EBENEZER SUBDIVISION

APPLICATION NUMBER 13 DATE June 5, 2003

APPLICANT Ebenezer Subdivision

REQUEST Subdivision

EBENEZER SUBDIVISION

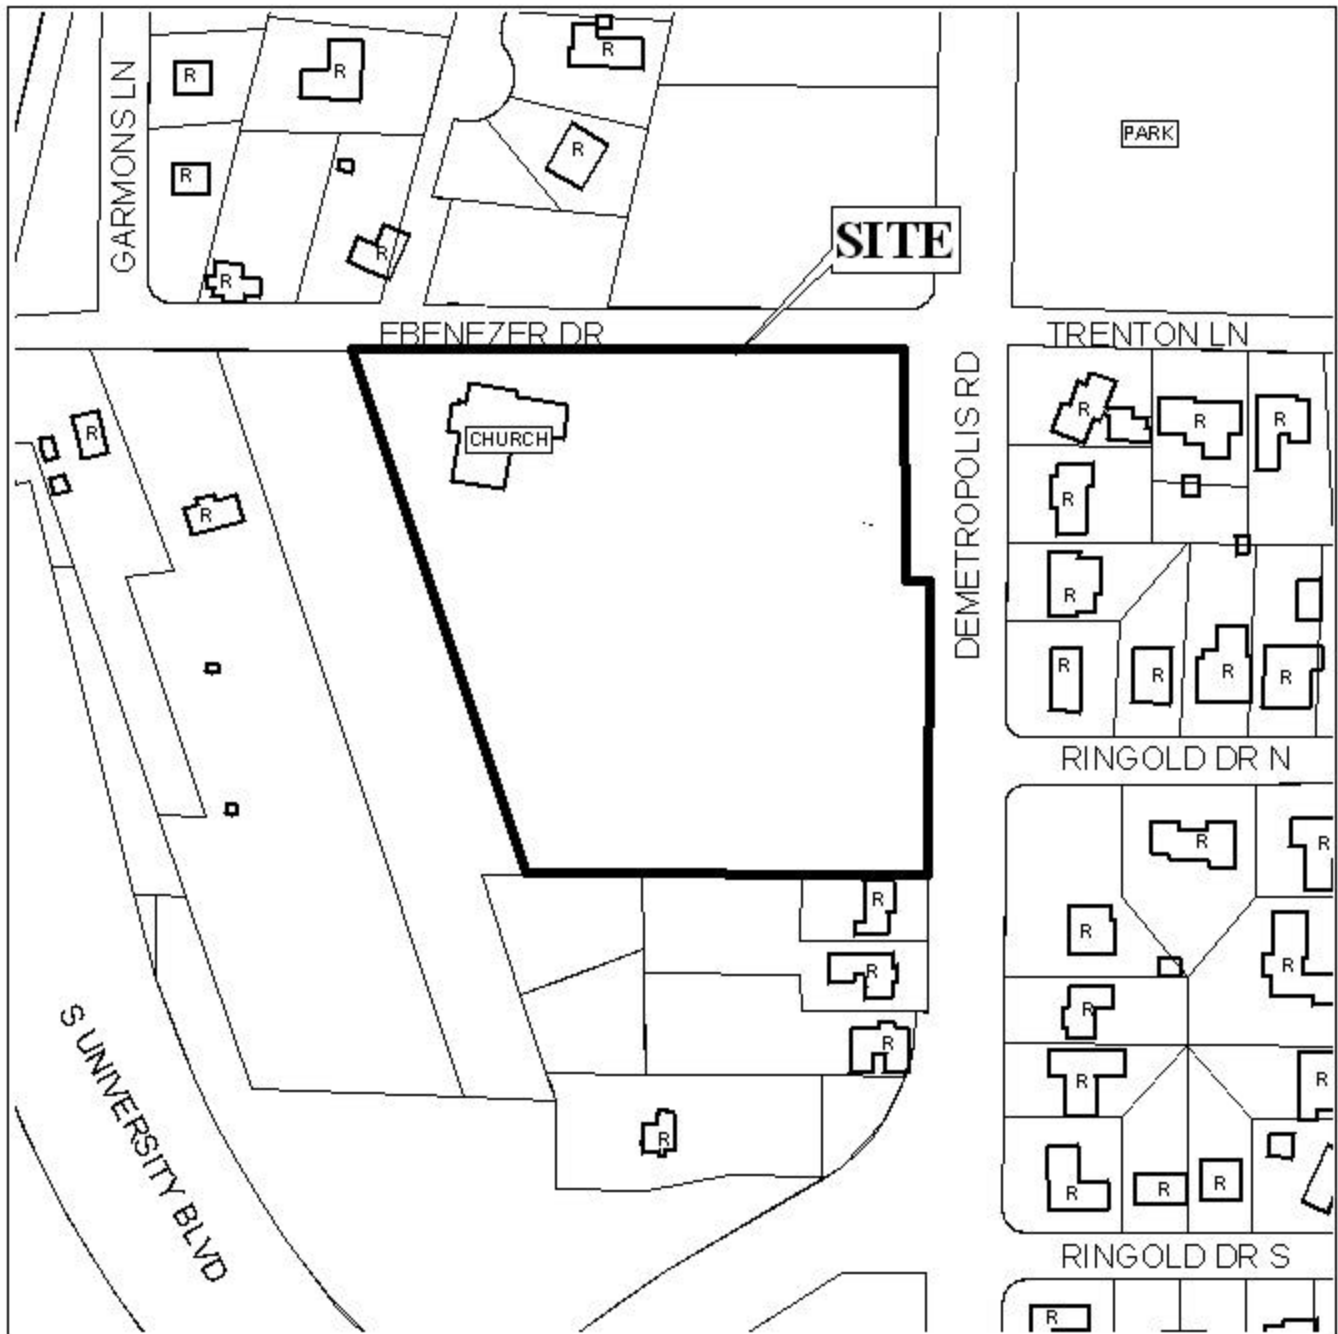
The twenty-five foot minimum building setback lines are not illustrated, but would be required on the final plat.

As a means of access management, the placement of a note on the final plat stating that the site is limited to two curb cuts to Ebenezer Drive, with the size, location and design to be approved by Traffic Engineering, should be required.

The City's Engineering and Real Estate Departments have researched a questionable right-of-way bisecting the northern portion of the property and found no guidance the right-of-way was ever dedicated.

The plat meets the minimum requirements of the Subdivision Regulations and is recommended for Tentative Approval subject to the following conditions: 1) the placement of the 25-foot minimum setback line on the final plat; and 2) the placement of a note on the final plat stating that the site is limited to two curb cuts to Ebenezer Drive, with the size, location and design to be approved by Traffic Engineering, should be required.
